# **Landscape Referral Response**

Application Number:	DA2025/1496	
Date:	06/11/2025	
Proposed Development:	Use of land as private roadway	
Responsible Officer:	Brittany Harrison	
- , , , , ,	Lot 1 DP 30019 , 79 Hilltop Road AVALON BEACH NSW 2107

Fig.1 Extract from Angophora Reserve Plan of Management as provided in the SEE.

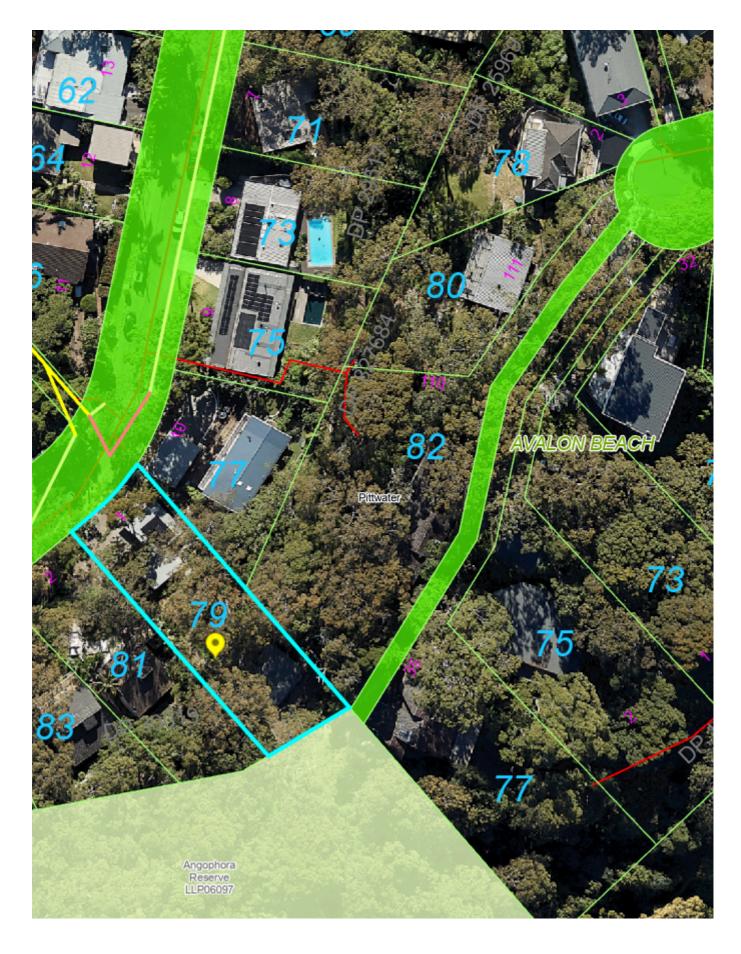
The extract from the Angophora Reserve Plan of Management provided in the SEE prohibits 'private alienation or encroachment'.(Fig 1 below).

As this application is not for 'emergency access, fire breaks and service trails' it appears that consent cannot be granted for the proposed use of the reserve for private access.(Fig 1 below).
